IWG TF-PP3, Discussion on 2/3 and 1/3 HIC Zones

2021-11-30

VW ID Buzz Concept

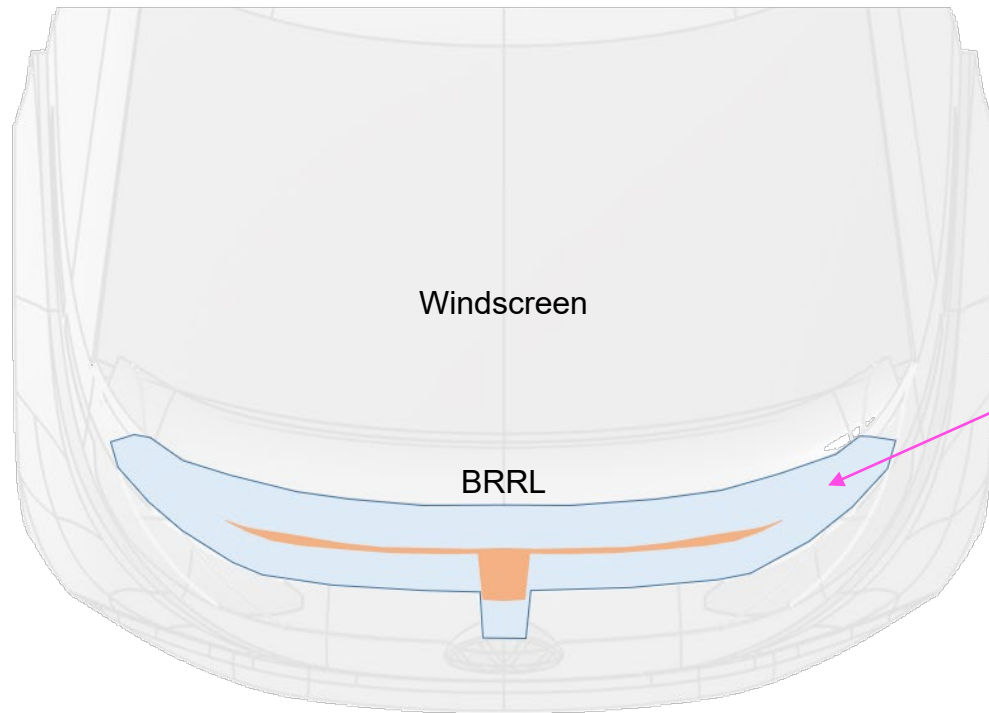
- › Example of a vehicle where there is no possibility to obtain 2/3 of all area within the impact area.
- › On such vehicles, no compliance with the NHTSA understanding would be feasible.

Head test area << 67% of bonnet top
